Sundry Print Report

Well Name: ROSS RANCH 10	Well Location: T26S / R31E / SEC 10 / SENE / 32.0593446 / -103.7595367	County or Parish/State: EDDY / NM
Well Number: 1	Type of Well: OIL WELL	Allottee or Tribe Name:
Lease Number: NMNM89057	Unit or CA Name:	Unit or CA Number:
US Well Number: 3001529605	Operator: DEVON ENERGY PRODUCTION COMPANY LP

Type of Action: Plug and Abandonment

8. Well Name and No. ROSS RANCH 10 FED 1 SWD

PROPOSED WELLBORE

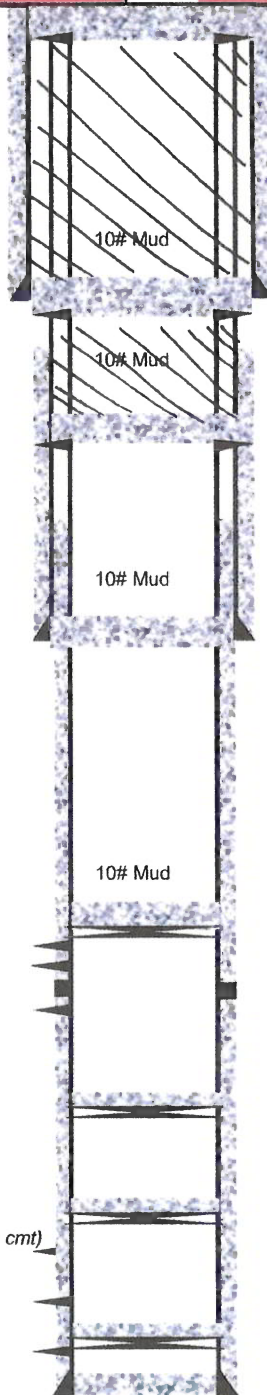
1. Perf @ ~~899'~~ ^{990'}
2. Sqz ~~75~~ ⁷⁸ sx Cl C from 899'-600' WOC & Tag. (Shoe @ 687', Rustler @ 849') (In 97 sx / Out 132 sx / Out 197 sx)

1. Perf @ ~~1205'~~ ^{1384' to 1030'}
2. Sqz ~~50~~ ⁵⁰ sx Cl C from ~~1205'-1010'~~ ^{1384'-1030'} WOC & Tag (Salt @ 1155') (In 36 sx / Out 49 sx)

1. Set CIBP @ 5068'. Tag. Circ 10# salt gel. Leak test.
2. Spot ~~20~~ ²⁵ sx Cl C from 5068'-4840'. (Perfs @ 5118', DV Tool @ 5320') (Perfs @ 5118', DV Tool @ 5320')
